# UNITED STATES PATENT AND TRADEMARK OFFICE

APPLICATION NO.	FILING DATE	FIRST NAMED INVENTOR	ATTORNEY DOCKET NO.	CONFIRMATION NO.
09/771,637	01/30/2001	Erich Harsch	82673-0006	1282

**NON-RESPONSIVE**

Fig. 4

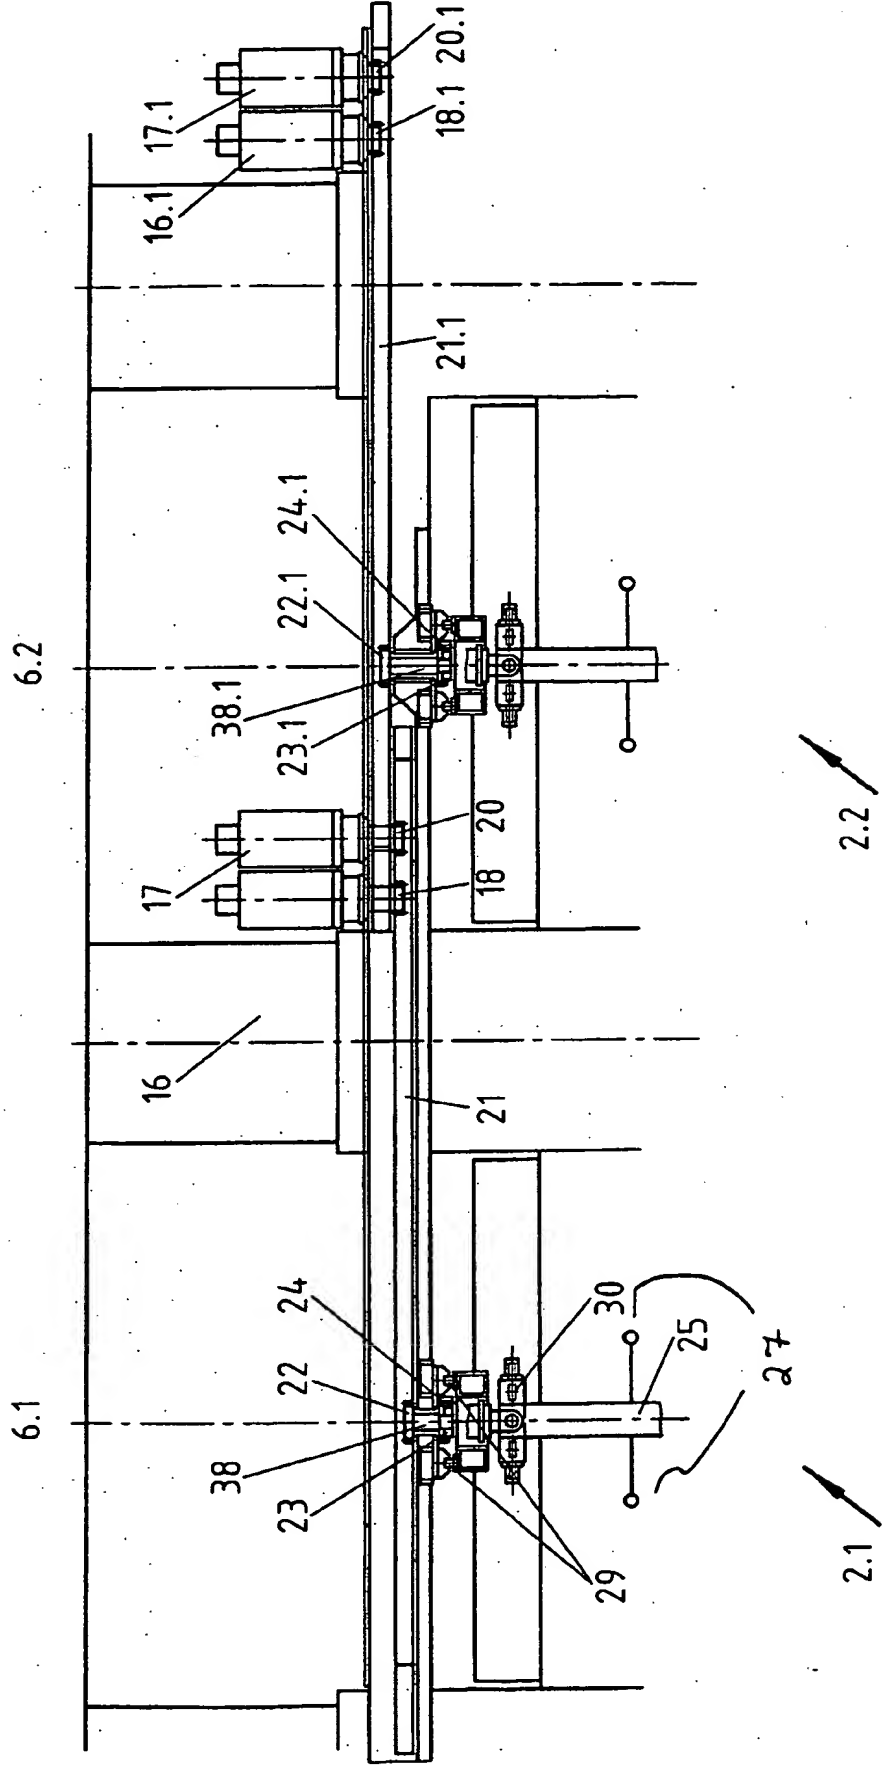
The reply filed on March 8, 2005 is not fully responsive to the prior Office Action because of the following omission(s) or matter(s): The addition of numeral 27 to figure 4 in the drawing to denote retaining means is not acceptable since numeral 27 is already used in figure 5 to denote an axis. The drawing and the specification should be corrected to use a heretofore unused numeral to denote the retaining means. Also the introduction of numeral 60 in figure 5 and the specification, page 10, is considered new matter. These amendments should be deleted. See 37 CFR 1.111. Since the above-mentioned reply appears to be *bona fide*, applicant is given **ONE (1) MONTH or THIRTY (30) DAYS** from the mailing date of this notice, whichever is longer, within which to supply the omission or correction in order to avoid abandonment. EXTENSIONS OF THIS TIME PERIOD MAY BE GRANTED UNDER 37 CFR 1.136(a).

*not approved  
 went 05/03/05*

Fig. 5

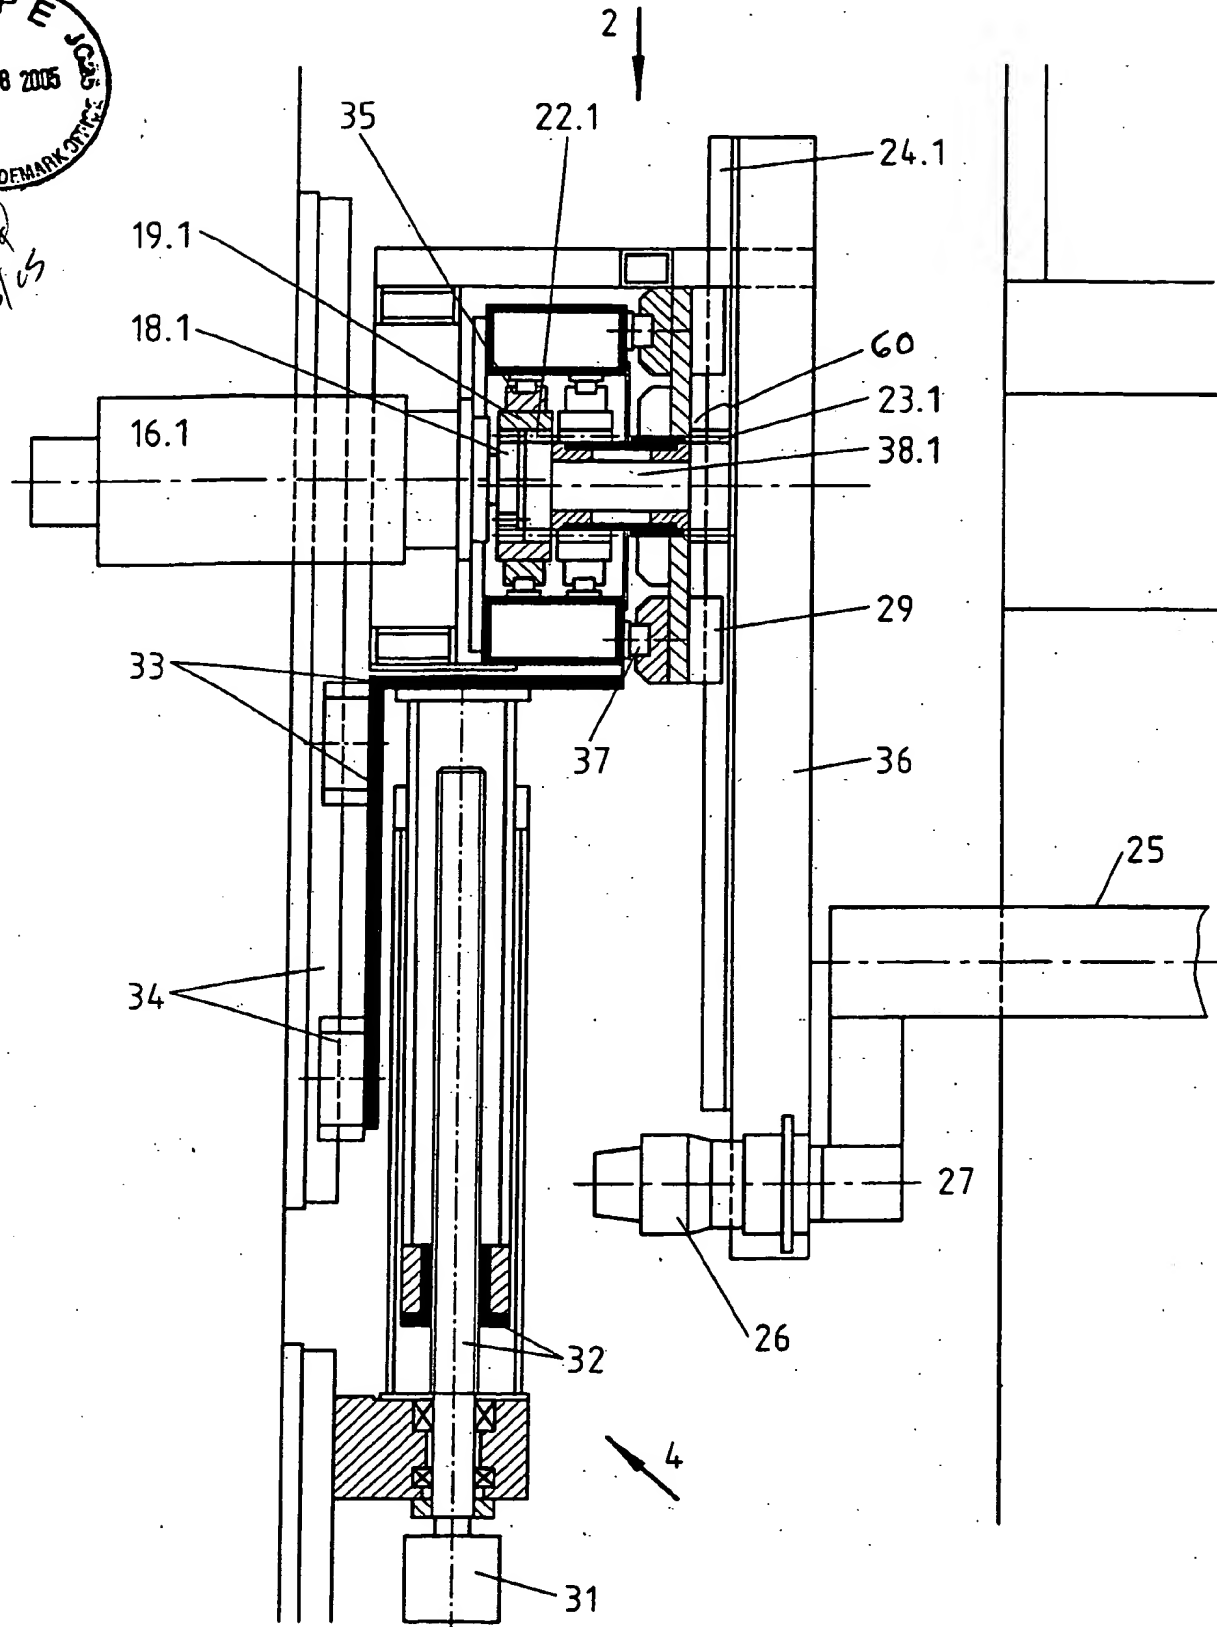
*not approved  
new 05/23/05*
